ADDENDUM 1

Wednesday, February 8, 2023

Project Name: ED 2 N 4th Floor Reno Rms 4223, 4224, 4225
Notice Number: PN22-106819

6 TYP. ADA BASE CABINET

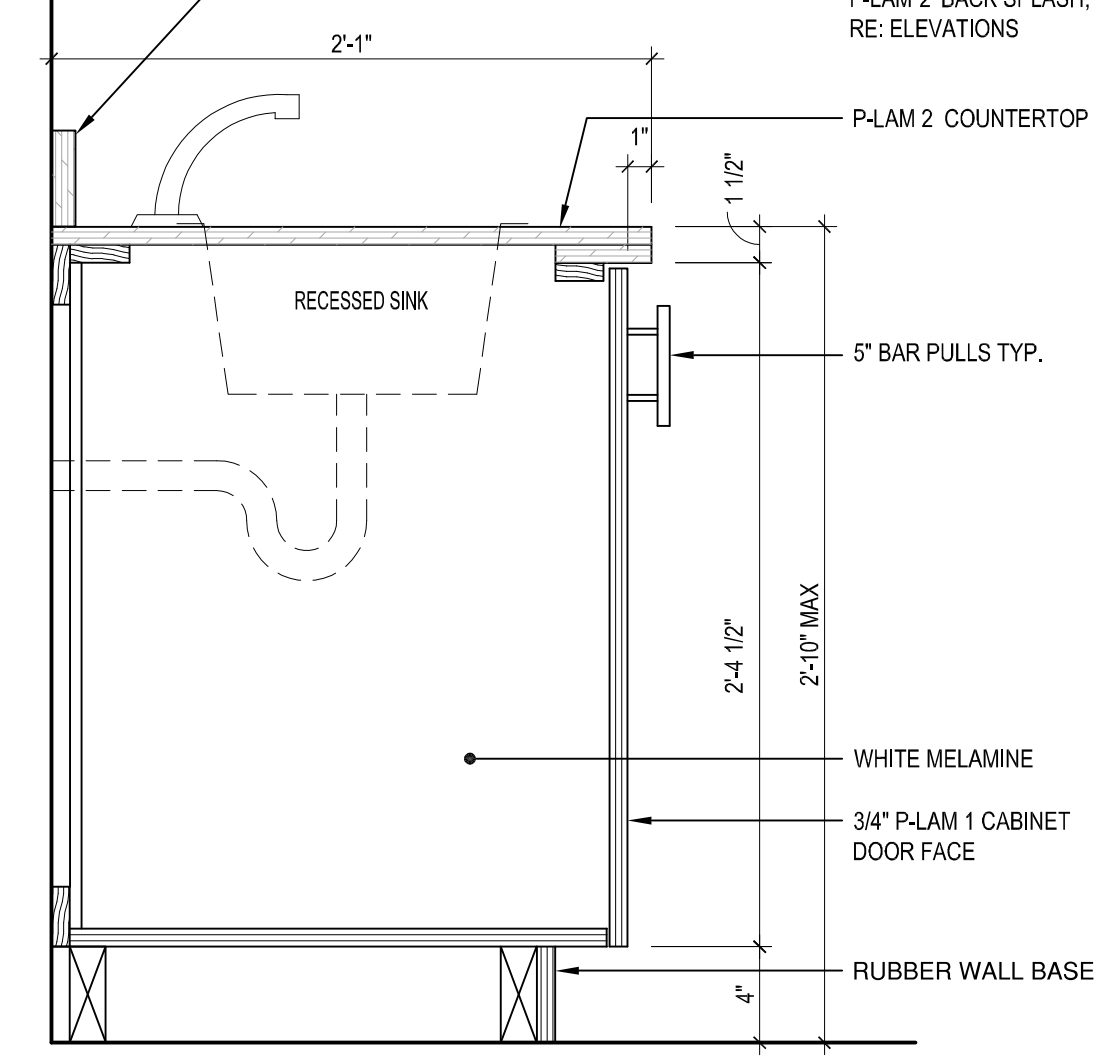
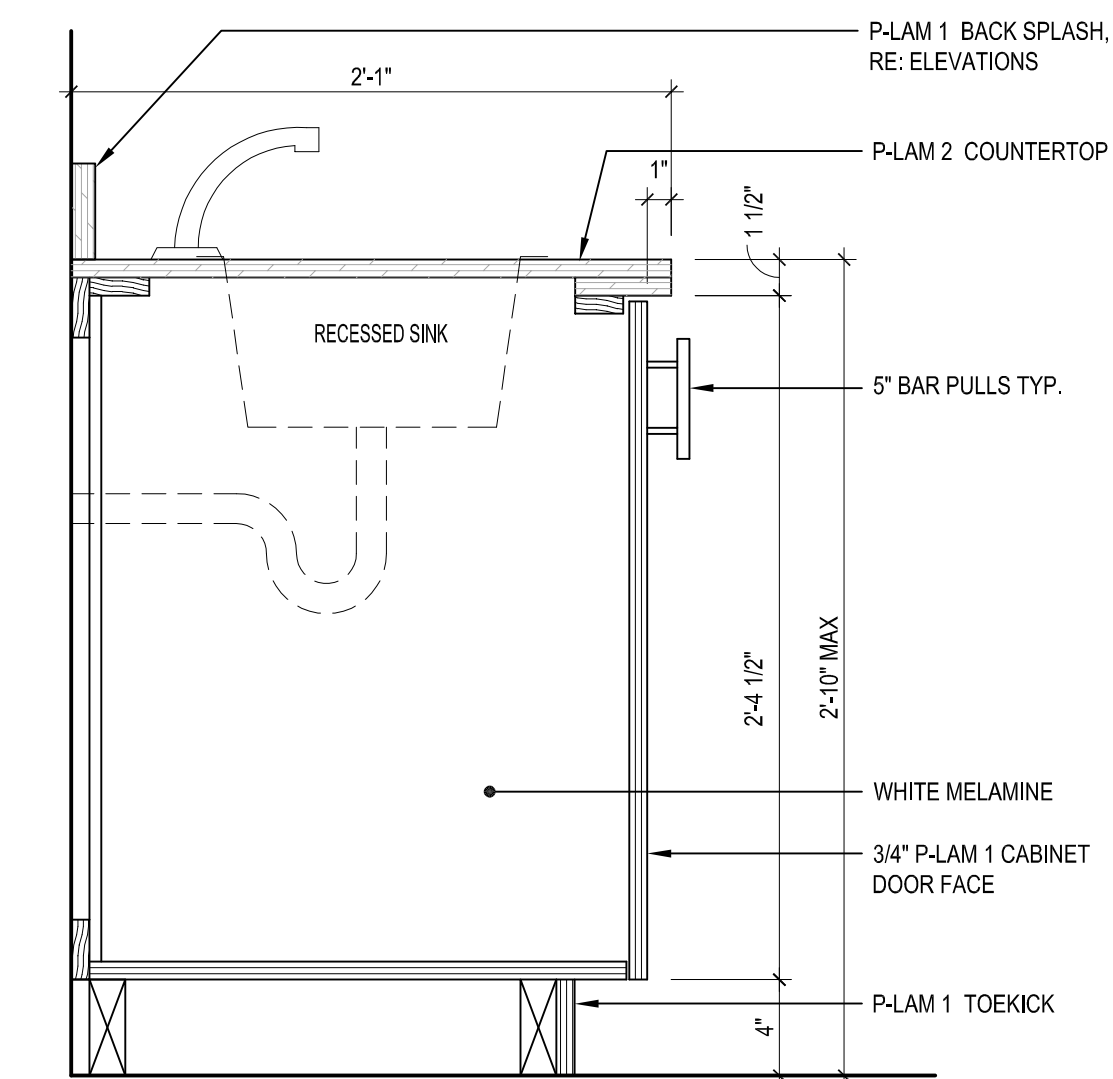
D2 - Sheet A-401: Finish schedule added, detail 7 updated to hollow metal detail, detail 5&6 P-LAM type corrected, and rubber base called out for finish kick. (SEE ATTACHMENT 3)
